DEVELOPMENT APPLICATION ASSESSMENT REPORT

ITEM No.	
FILE No.	DA 315/2015/1
ADDRESSES	163A Victoria Rd Bellevue Hill (Bellevue Hill Public School) and 19A Bellevue Park Rd, Bellevue Hill (Bellevue Park)
SITE AREA	7214m ² (Bellevue Hill Public School)
ZONING	SP2 Infrastructure
PROPOSAL	Expansion and upgrade works to Bellevue Hill Public School to facilitate an increase in student numbers from 550 to 1000, an increase in staff numbers from 37 to 72, to provide upgraded /expanded facilities and the temporary relocation of 3 demountable buildings to the adjoining Bellevue Park
TYPE OF CONSENT	Local development
COST OF WORKS	\$12,860,684
DATE LODGED	18/06/2015
APPLICANT	Mr B Crompton
OWNER	NSW Department of Education and Communities (Bellevue Hill Public School) NSW Department of Primary Industries-Crown Lands (Bellevue Park)
AUTHOR	Mr D Booth
TEAM LEADER	Ms E Smith
RECOMMENDATION	Refusal

Images of documented affected trees

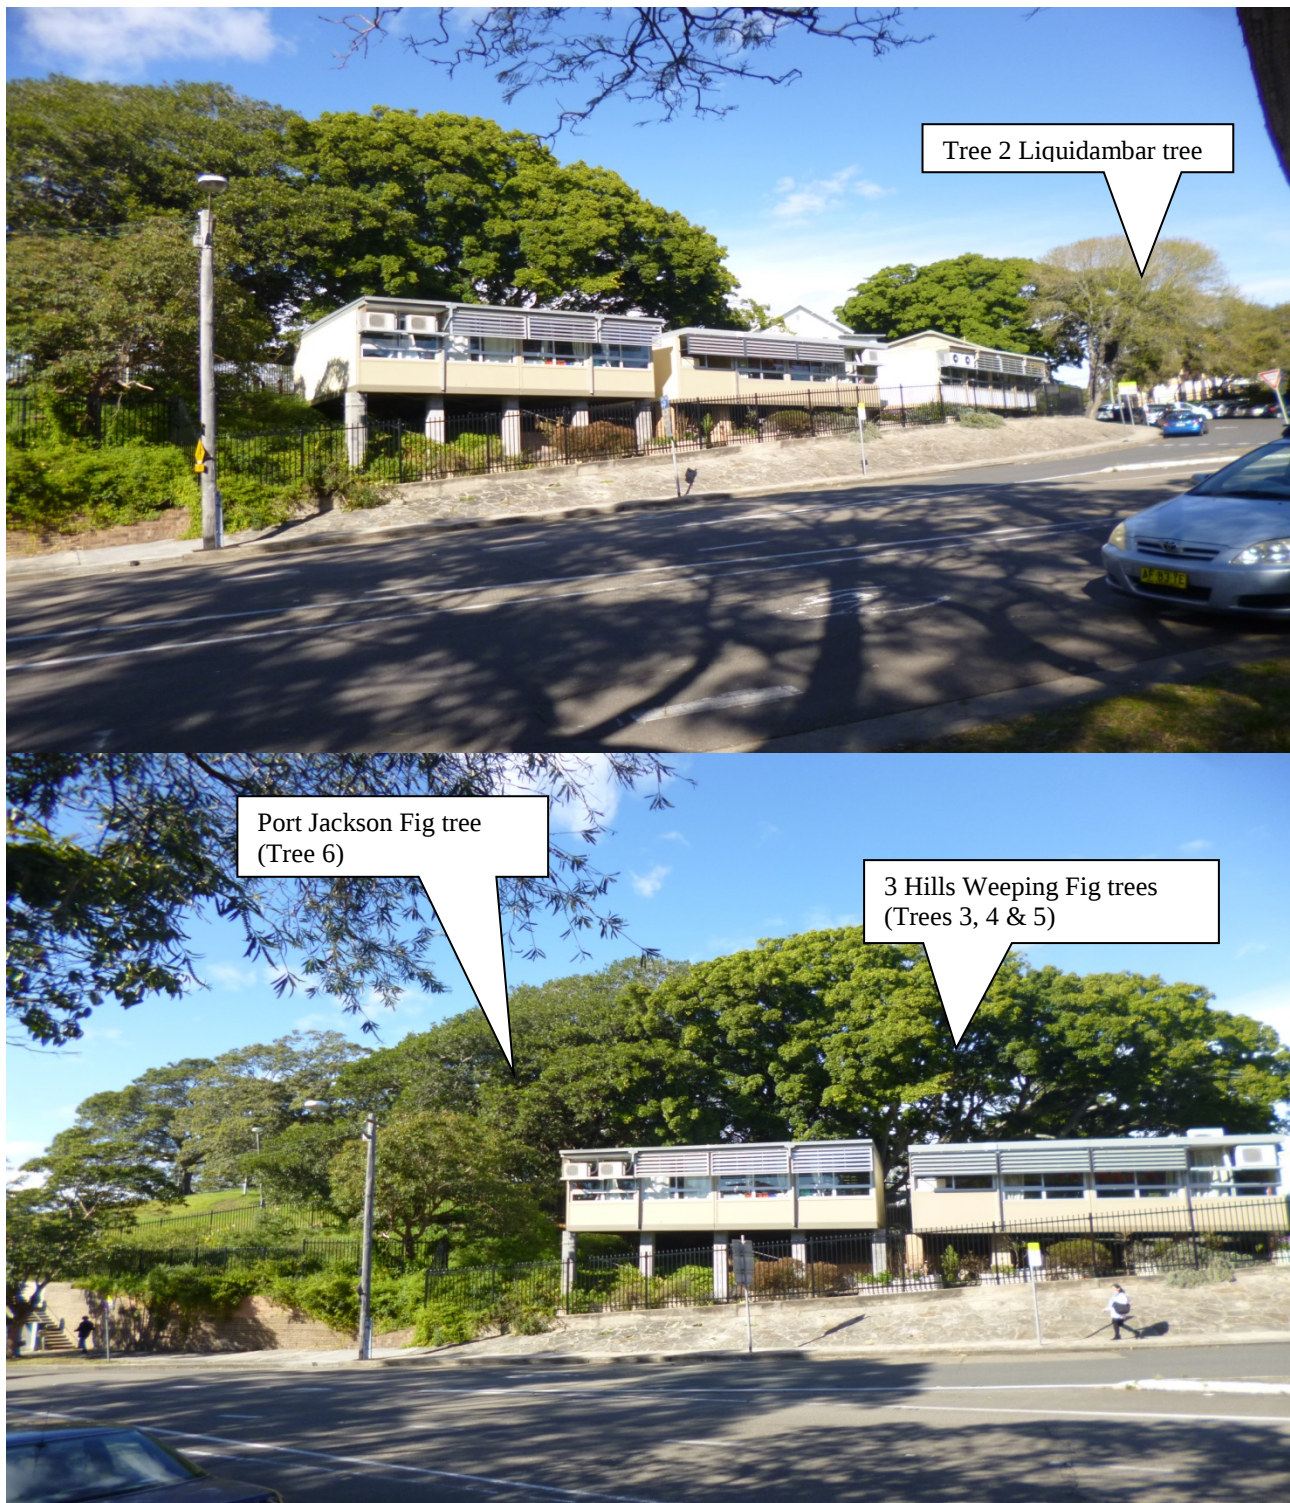
The applicant has provided the following case for the proposed removal of all 3 substantial Hills Weeping Fig trees located within the subject site and the severe pruning (approximately 50%) of a substantial Port Jackson Fig tree located in Bellevue Park:

In order to accommodate the new building, trees will require pruning. Several trees including the 3 Hills Weeping Fig trees will also require removal. In order to retain these trees, significant alterations to the design of the building would be required. This would result in a substantial reduction in the floor space of the new school building, equating to a reduction in

the school's educational capacity. It will also compromise the design and functionality of the building, as a significant portion will need to be deleted from the building. Trees will require removal and pruning. The benefits of this new school building however outweigh any impacts associated with tree removal.
